MEMORANDUM

To: Planning Commission

From: Anne McClung, Planning and Building Director

Subject: RZN 17-0006 – Request to rezone the Old Blacksburg Middle School property at 501 South Main Street from R-4 Low Density Residential to Downtown Commercial (DC) and Planned Residential zoning districts by Steve Semones (agent) on behalf of Midtown Development Partners LLC (applicant/owners).

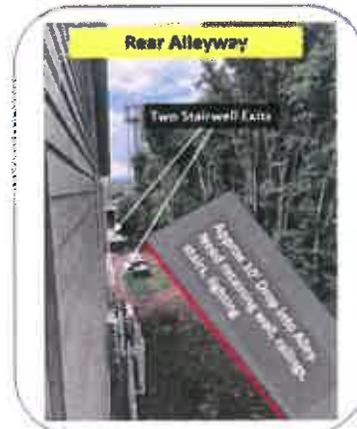
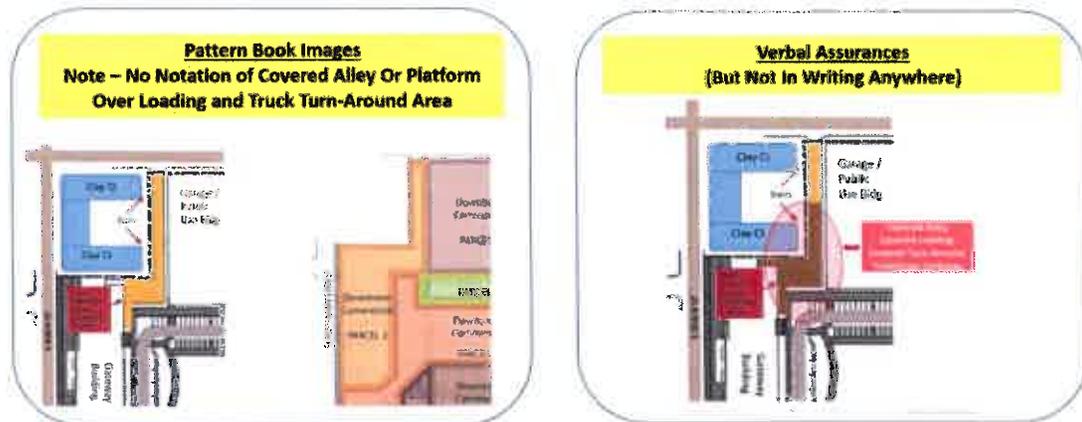
Of particular concern is the rear alley design. Currently the easy answer seems to be to defer and not address a solution in a holistic fashion with the entire Midtown Project design and approval. The parties seem to wish to push it downstream until the public use building is designed and until the Gateway Building submits for approvals. This does not satisfy us. Instead we would like to see the Town act now and proffer certain conditions as being required of both the Midtown development and the Gateway Building. Pushing a decision back in time to the future developer of the Gateway Building will be too late. By then the footprint of the road, the land plats, turnarounds, covered areas, stairwells, retaining walls, railings, lighting and other details would have already been cast. Once the land is subdivided it will be too late.

See the diagrams below.
